This document summarizes the EAQ for Daybreak Foods, Creekwood. The original EAQ was submitted in 2017. Upon review of the submittal, the WDNR sent requests to the farm for additional information in some areas. These requests are written below each question in blue. In response to the requests, the farm submitted new answers in some areas. The revised answers submitted by the farm are written below each requested revision. For answers that refer to attached documents, the location of these documents is written in red.

ENVIRONMENTAL ANALYSIS QUESTIONNAIRE

Livestock Operations

*Daybreak Foods, Inc.
Creekwood*

FIG. 2

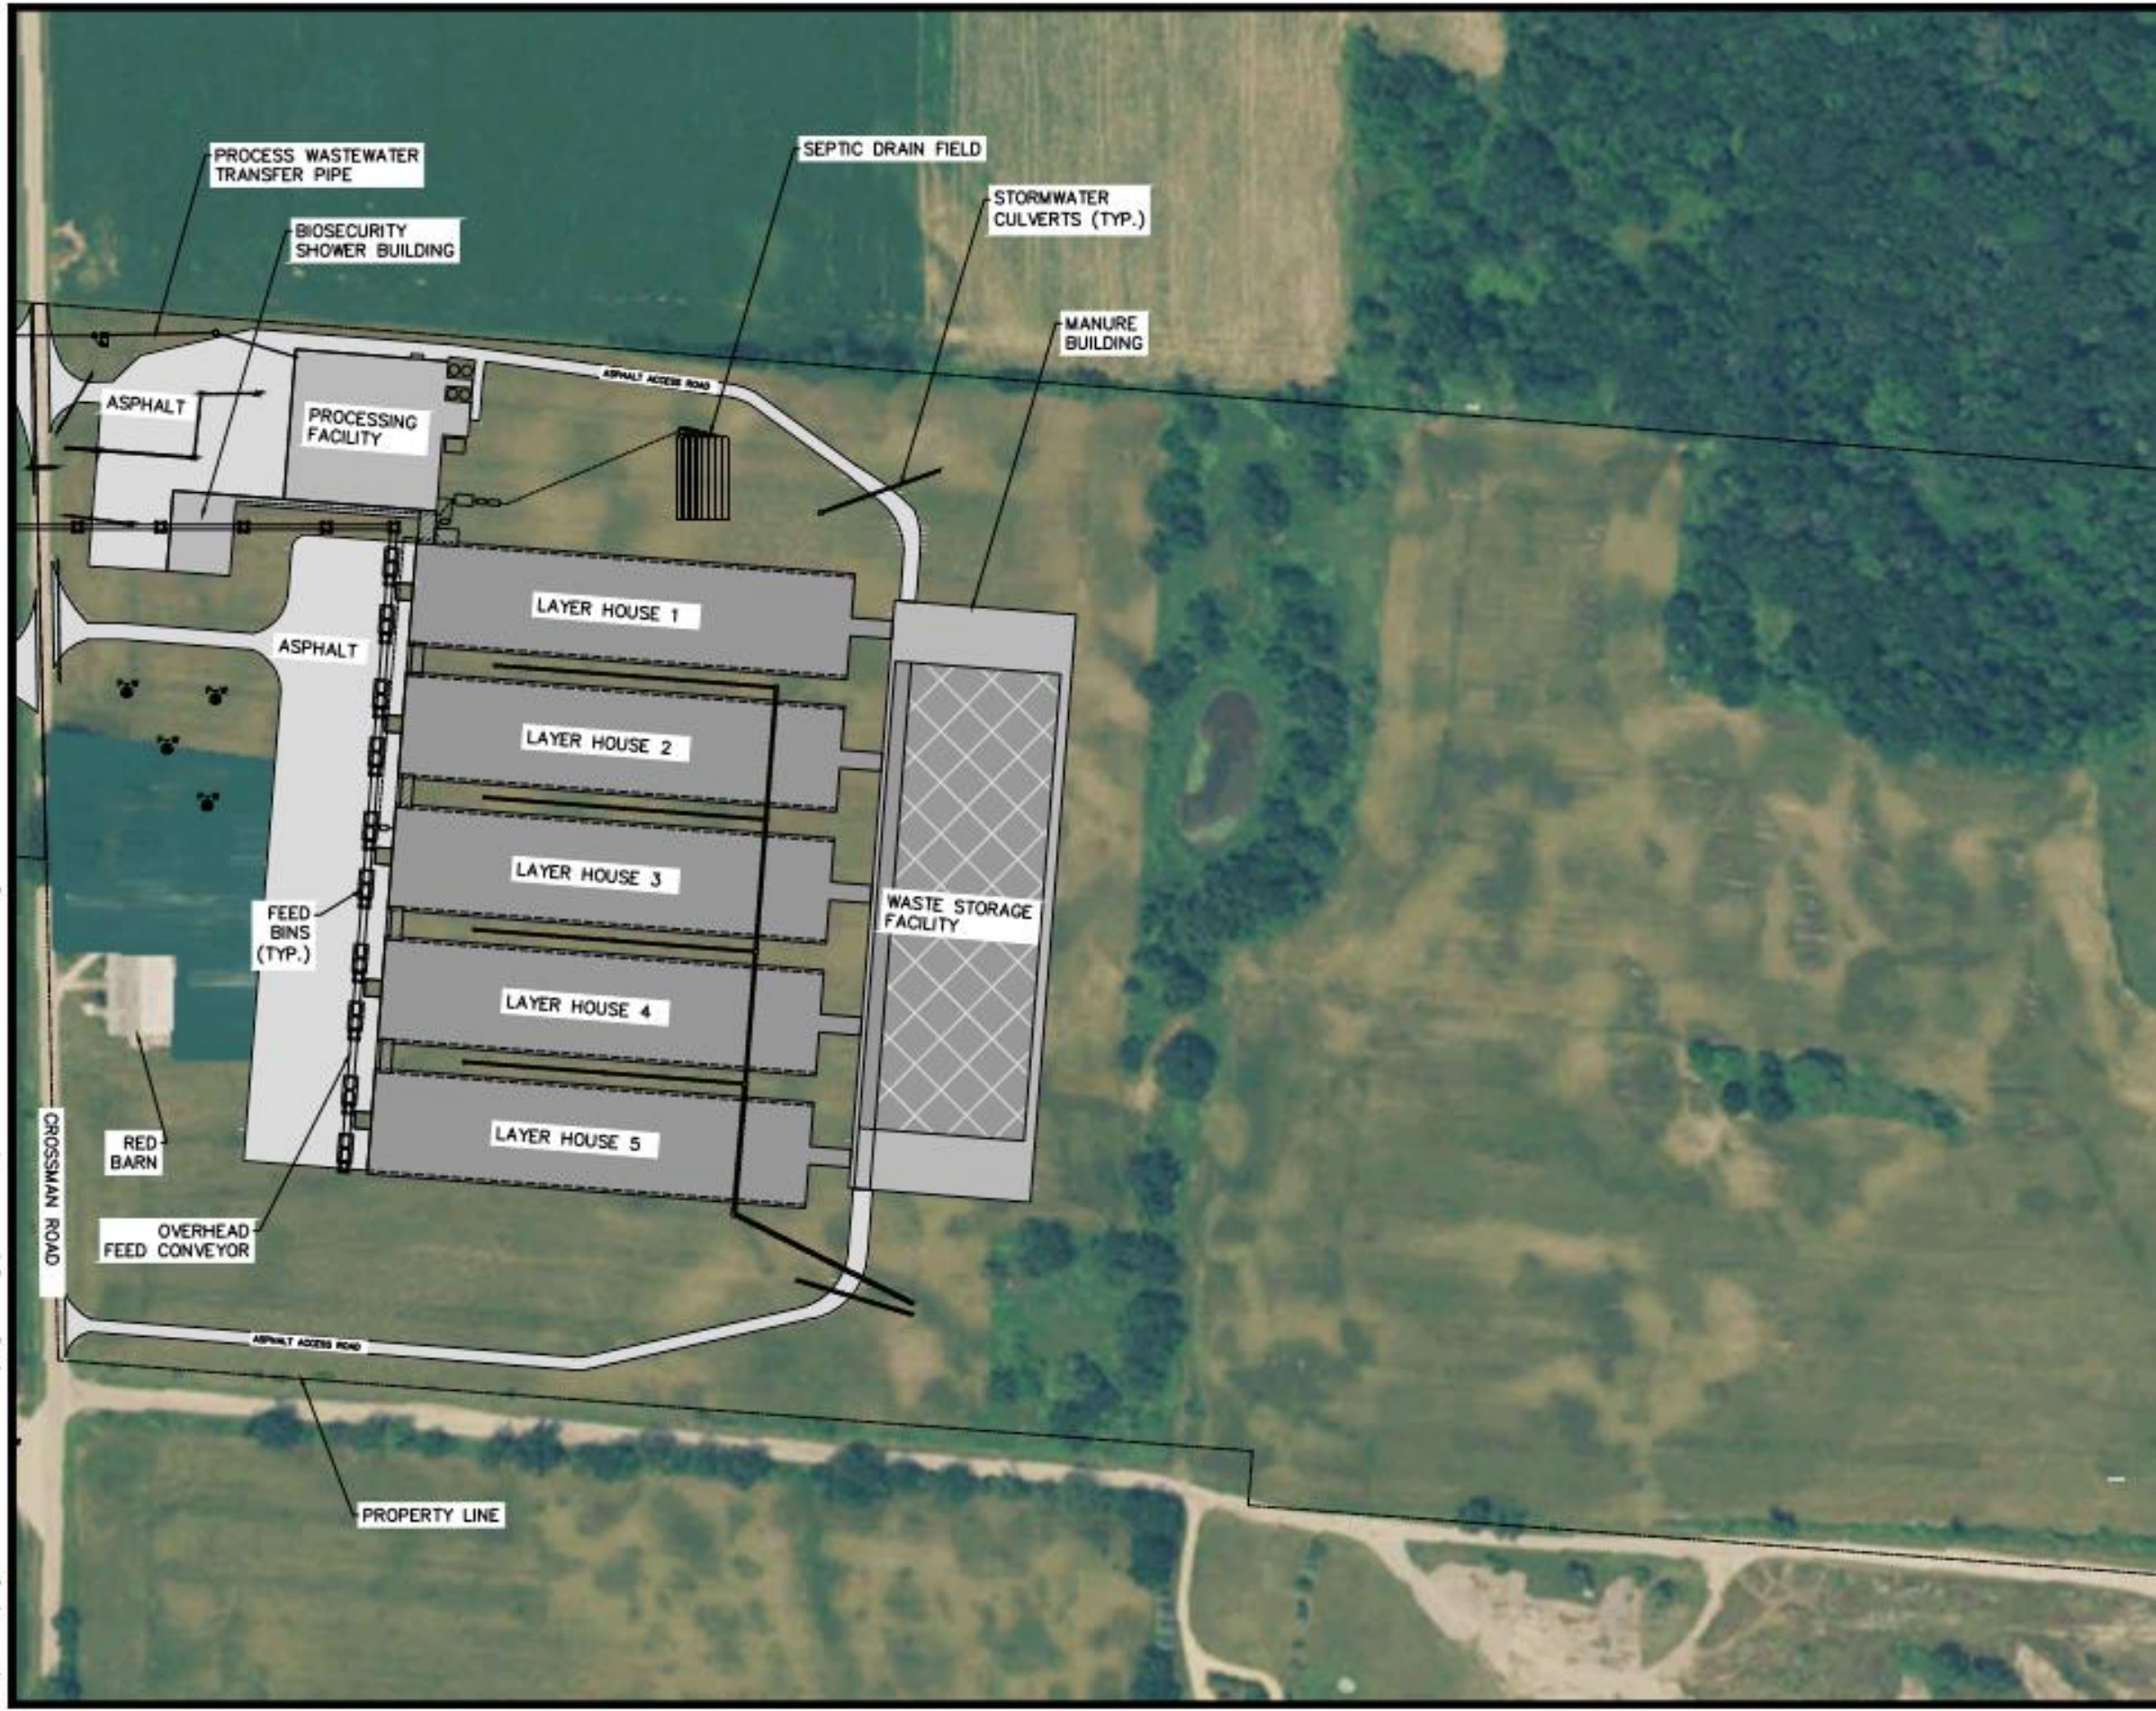
Requested Revision: Provide updated maps.

Requested Revision: Provide specific information on the location and capacity of individual wells. State whether or not any of the wells will be classified as “high capacity” (70 gal/min).

Response: See attached maps. (updated maps located on pages 29-32)

The two (2) new wells constructed at the pullet site are 150 gpm high capacity wells to supply water to the three new aviary cage free pullet structures, the existing conventional pullet building and the new pullet site biosecurity shower in/out building, along with fire protection water to two fire hydrants. Capacities have been designed to meet the flock requirements as well as fire department water supply pressures and flows.

Four (4) new high capacity wells supply 200 gpm water each to the five new aviary cage free layer buildings, the new egg processing plant and the new layer bio-security shower in/out and office building, as well as domestic water to the new feed mill. The same water system will also supply fire protection water to fire department located fire hydrants on the layer and feed mill site.
